ANN ARBOR HISTORIC DISTRICT COMMISSION**Staff Report****ADDRESS:** 415 W William Street, Application Number HDC24-0170**DISTRICT:** Old West Side Historic District**REPORT DATE:** January 9, 2025**REPORT PREPARED BY:** Mariana Melin-Corcoran, City Planner**REVIEW COMMITTEE DATE:** January 6, 2025**OWNER****APPLICANT****Name:** Sarah Okuyama

APPLICATION: The applicant seeks HDC approval to install a radon mitigation system on the east side of the building, next to the front porch and near the street.

STAFF FINDINGS

Proposed Location

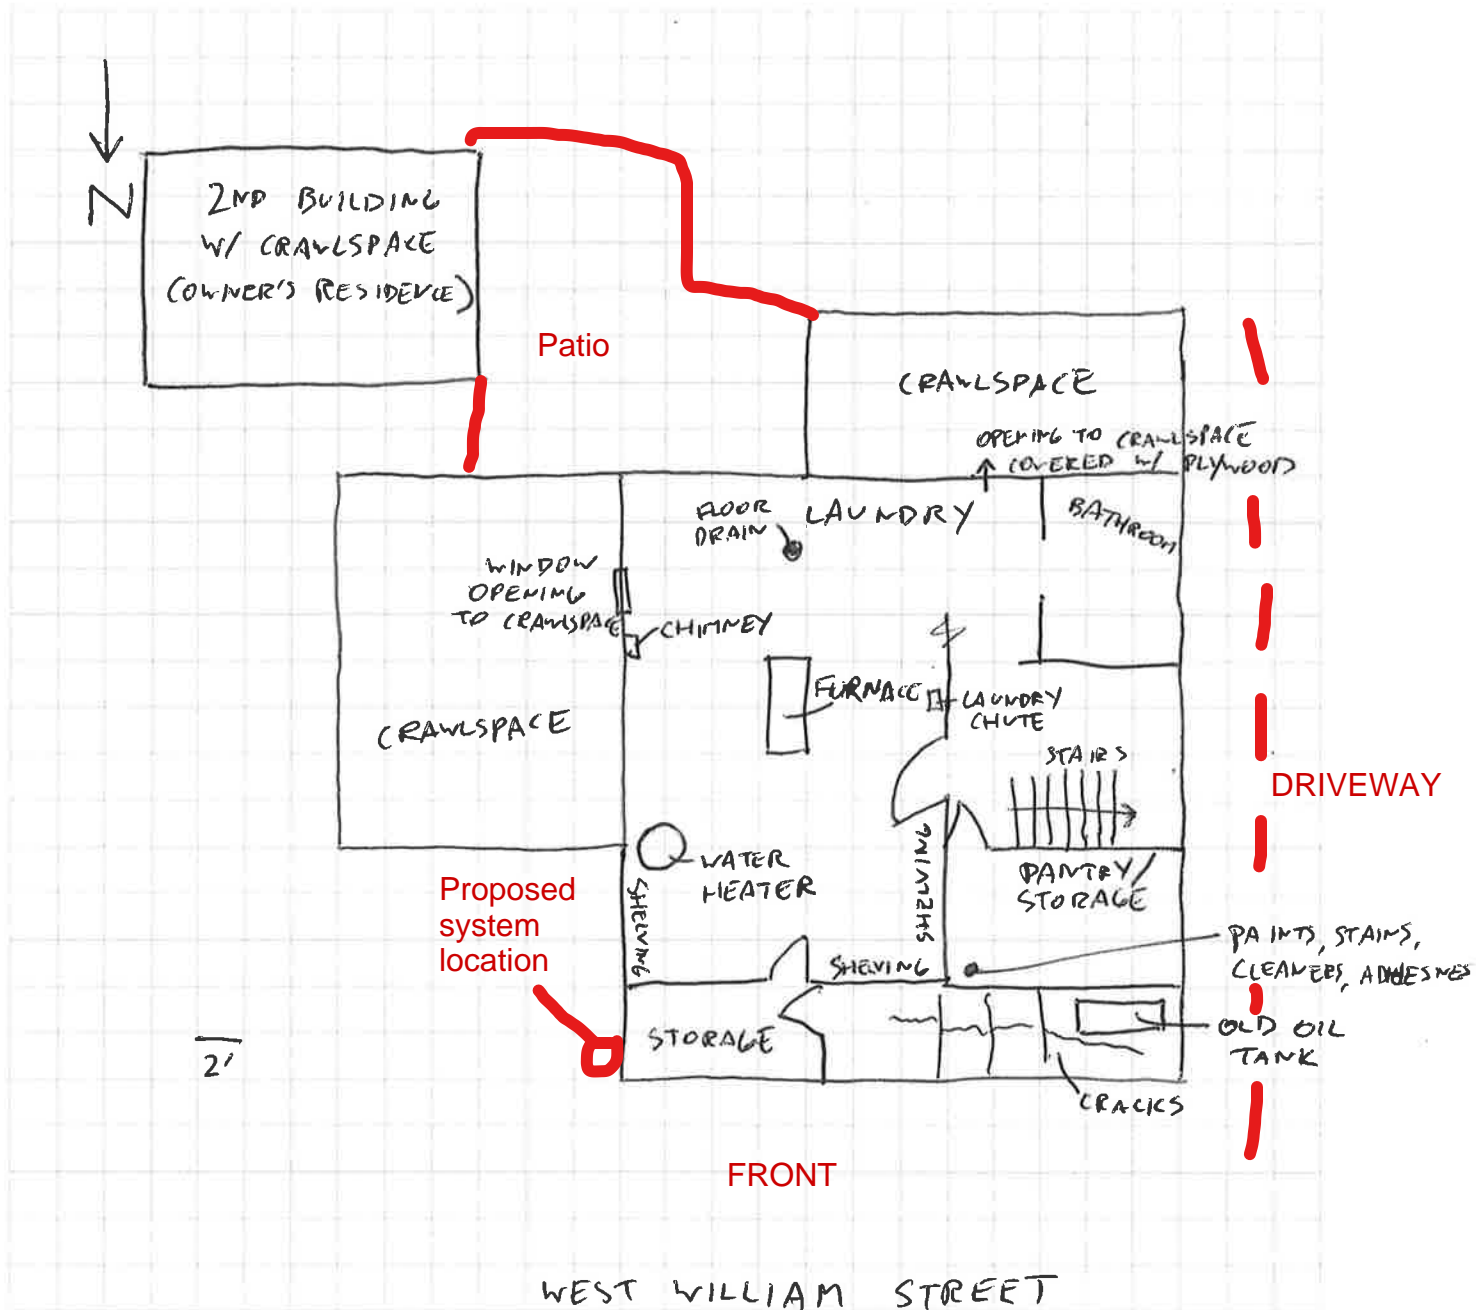
2. Based on samples taken by the applicant, a long-term mitigation system is necessary at 415 W William St. However, staff does not feel that the applicant has provided adequate justification for the proposed placement of the radon mitigation system, which is highly visible from the street along the east façade, above the roof eave, and directly adjacent the historic front porch. This placement does not meet the Historic District Design Guidelines.

3. Staff recommends placing the mitigation system in a different location that is less visible and farther from the street. Mechanical systems are approvable when they are hidden from the right of way. If the HDC finds that this is the only possible location for the radon mitigation system, staff recommends that the mitigation unit be painted to blend in with the exterior.

I move that the Commission issue a certificate of appropriateness for the application at 415 W William Street, a contributing structure in the Old West Side Historic District, to install a radon mitigation system near the northeast corner of the building, on the condition that the

entire radon unit is painted to match the exterior color. As conditioned, the work is compatible in exterior design, arrangement, materials, and relationship to the building and the surrounding area and meets *The City of Ann Arbor Historic District Design Guidelines* for mechanical equipment, and *The Secretary of the Interior's Standards for Rehabilitation and Guidelines for Rehabilitating Historic Buildings*, in particular standards 2, 9 and 10, and the guidelines for mechanical systems.

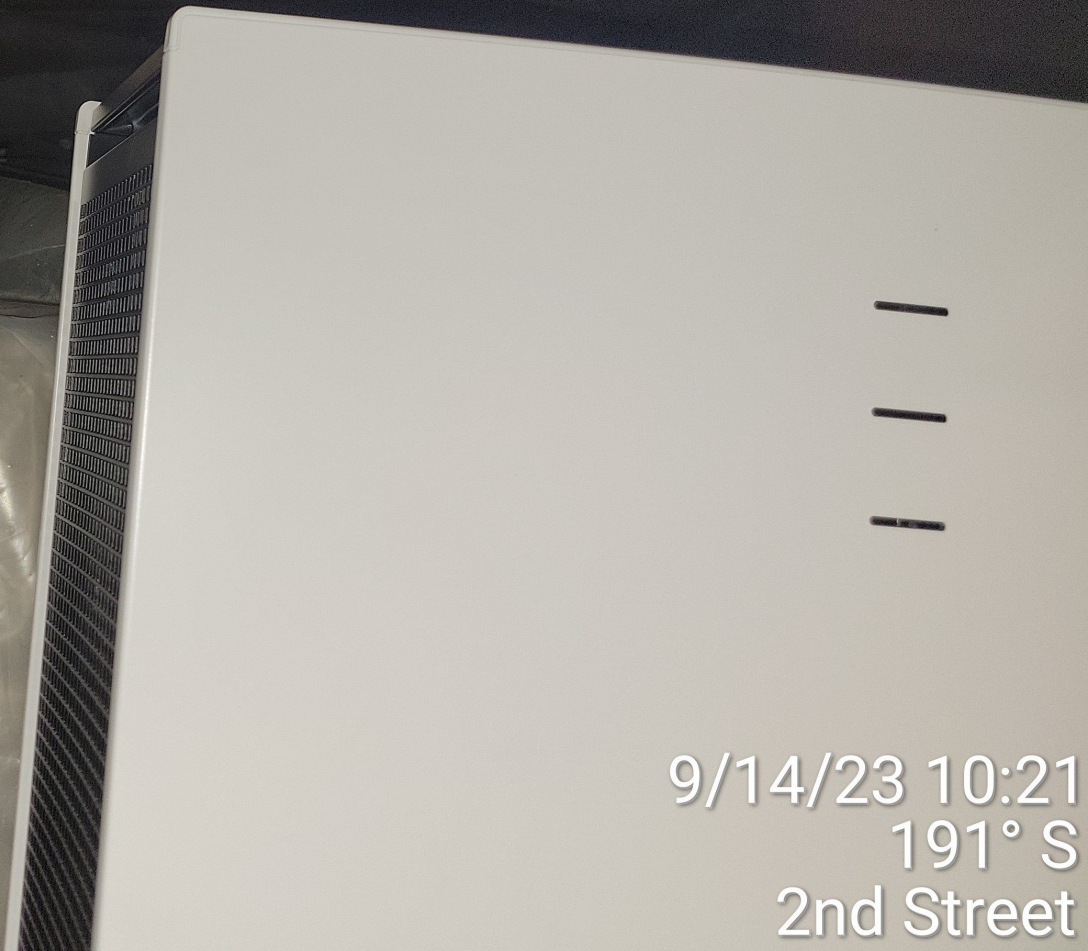
INSIDE CRAWL SPACE TO TIGHT FOR
SYSTEM INSTALLATION
